Bethesda Downtown Design Advisory Panel

Meeting Minutes

PROJECT: 4824 Edgemoor Lane
320200020 Sketch Plan Application

DATE: February 26, 2020

ALTERNATE MASSING OPTION

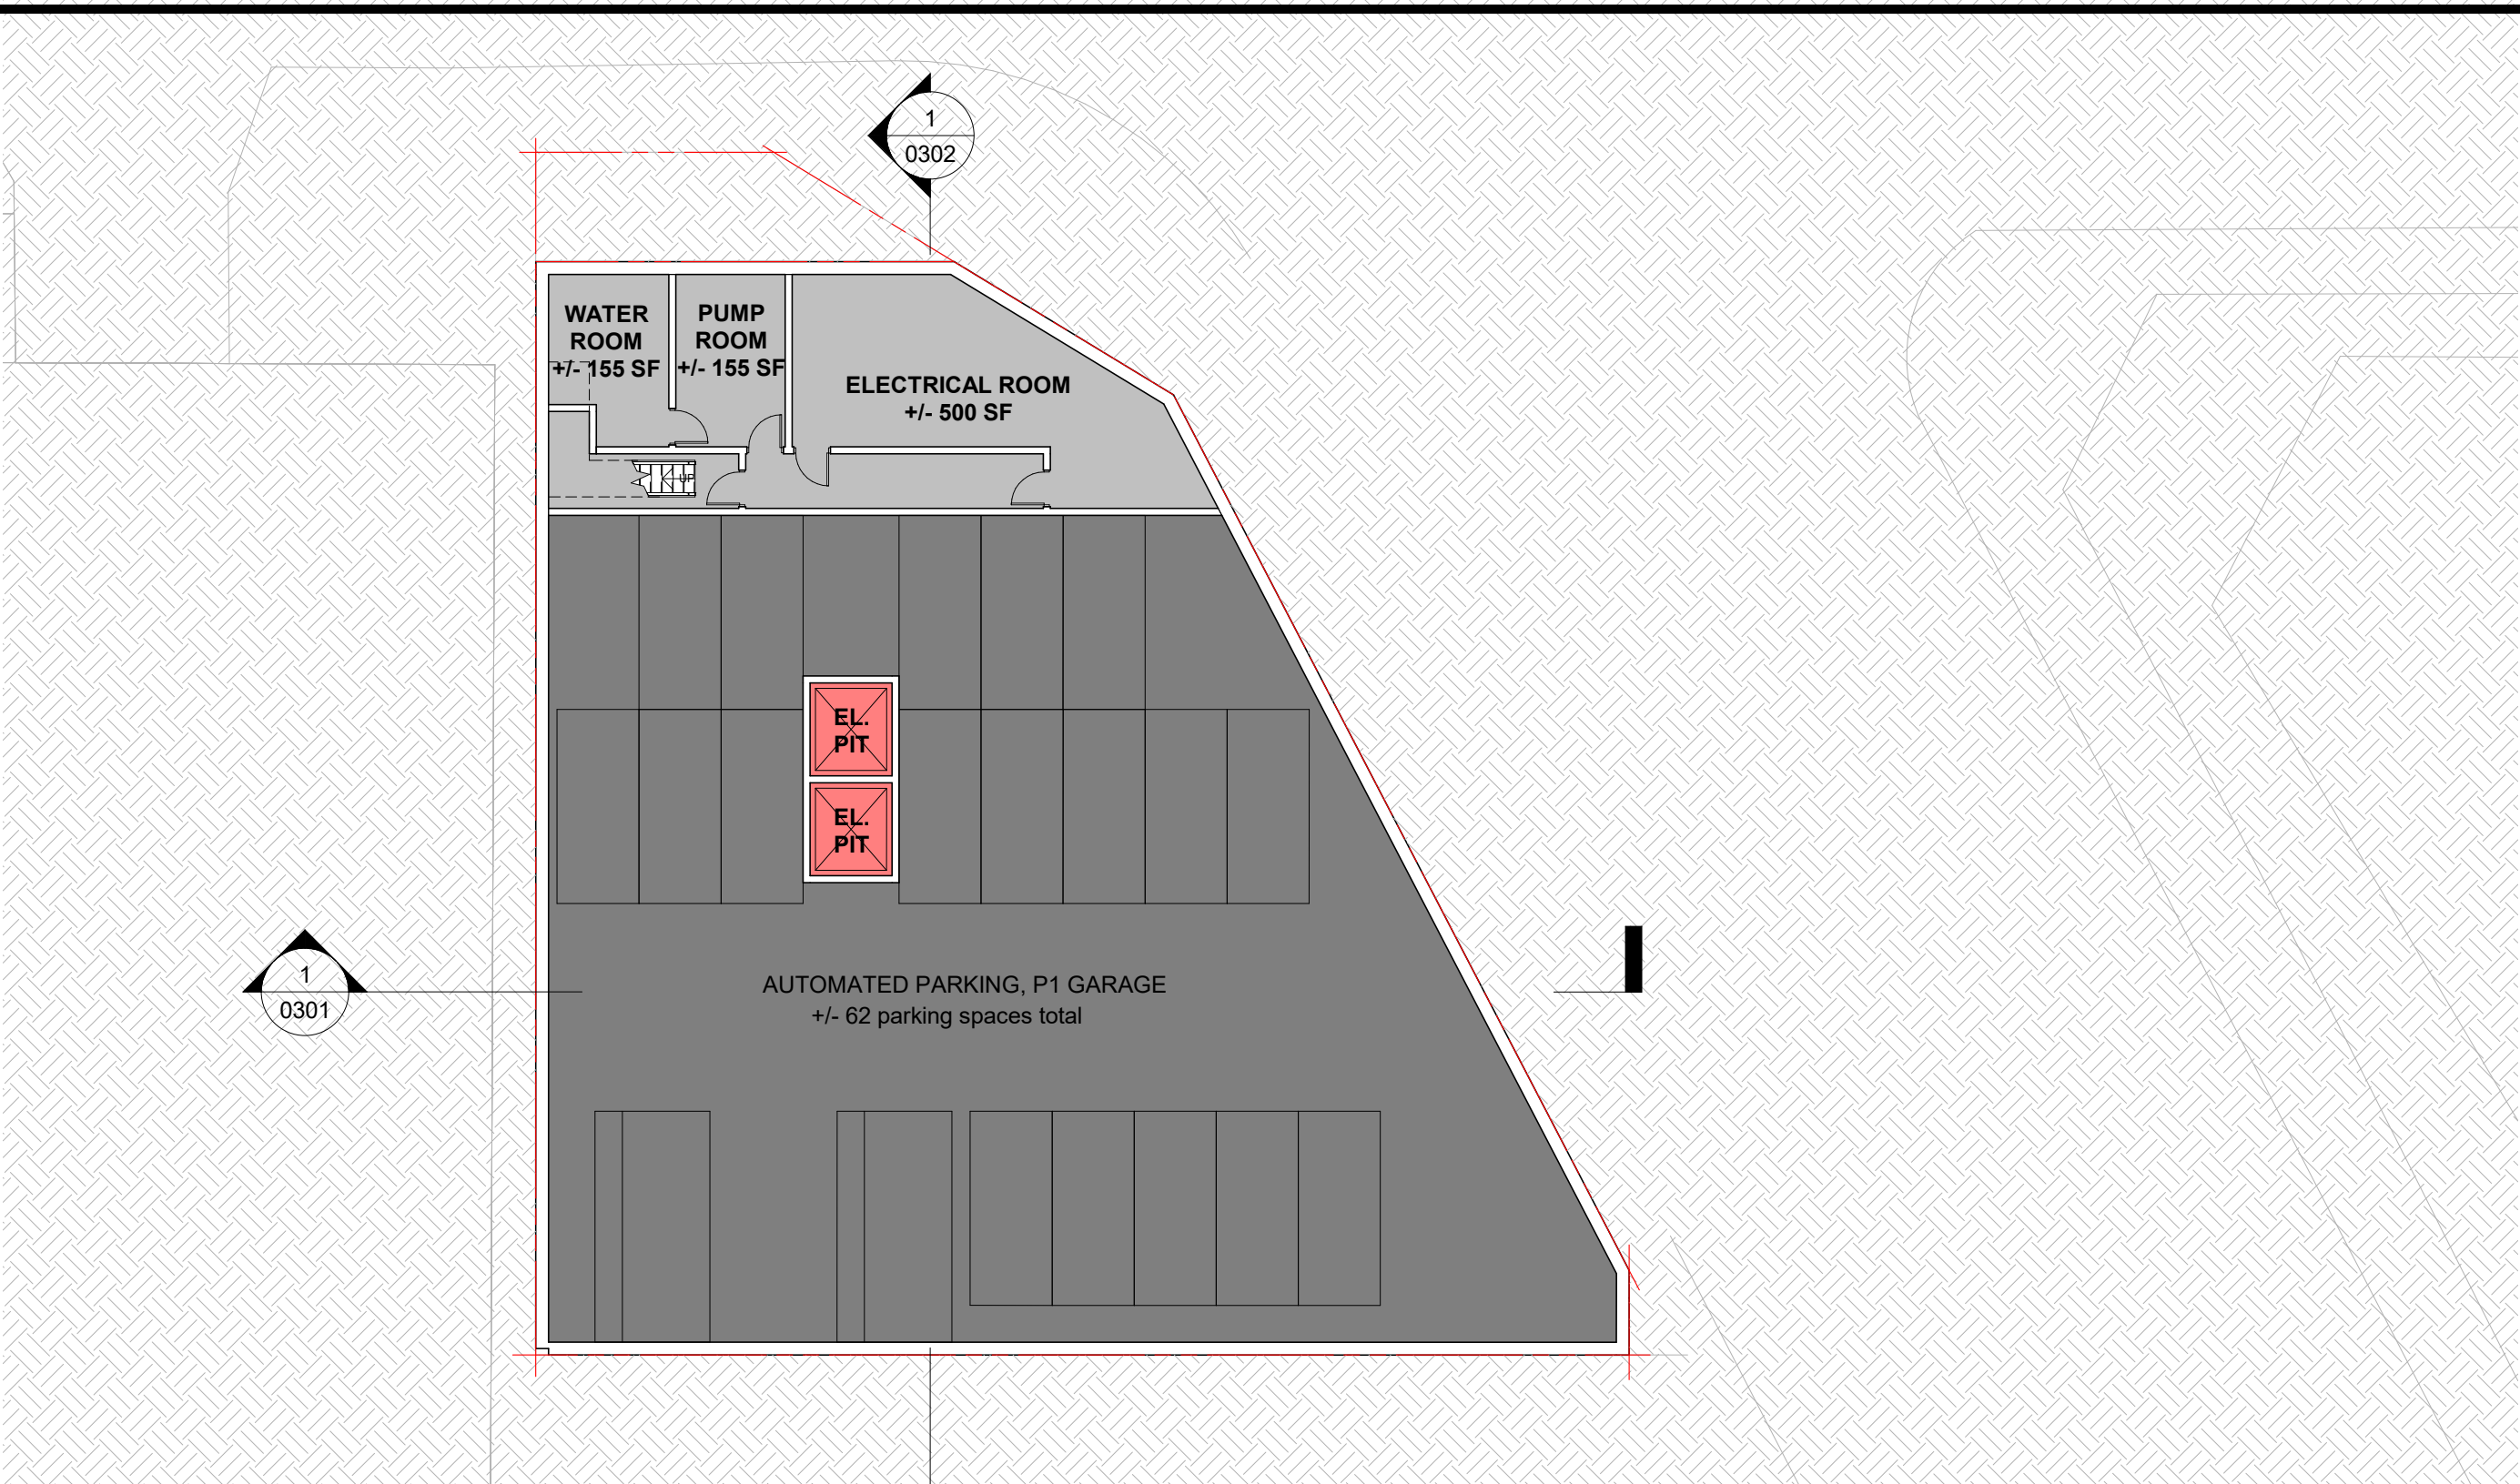
- For the south façade, do you have a preference between the two massings presented?
 - *Applicant Response: The first massing with the smaller amount of setback would be the preference. Given the steel structural type, it would be easier to construct.*

- Explore methods to increase tower separation above the base (4 stories) to achieve a minimum separation of 30' and an average of 40'.
